| <h1>AI</h1> | WEBB STREET PROPOSED ALTERATIONS | OCT 06, 2003 | 1/4" = 1'-0" | Project: FORE CHEV |
| | | 10-30-03 Footing Drains Added | | |

① 1st FLOOR
 1/4" = 1'-0"

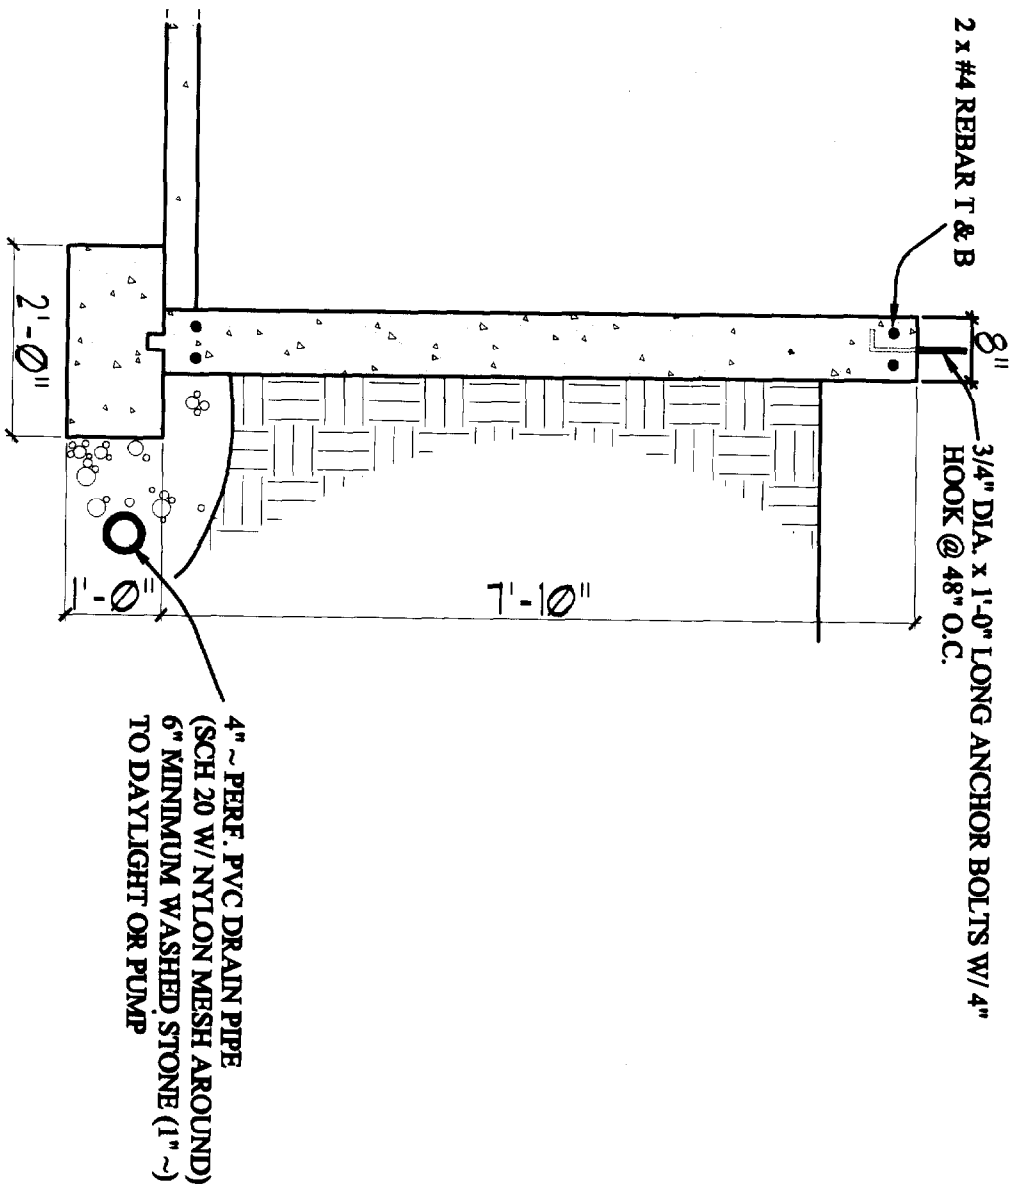
WINDOW OPENING WILL NEED TO BE
INCREASED, IN THIS LOCATION, TO MEET
EGRESS REQUIREMENTS

WINDOW OPENING WILL NEED TO BE
INCREASED, IN THIS LOCATION, TO MEET
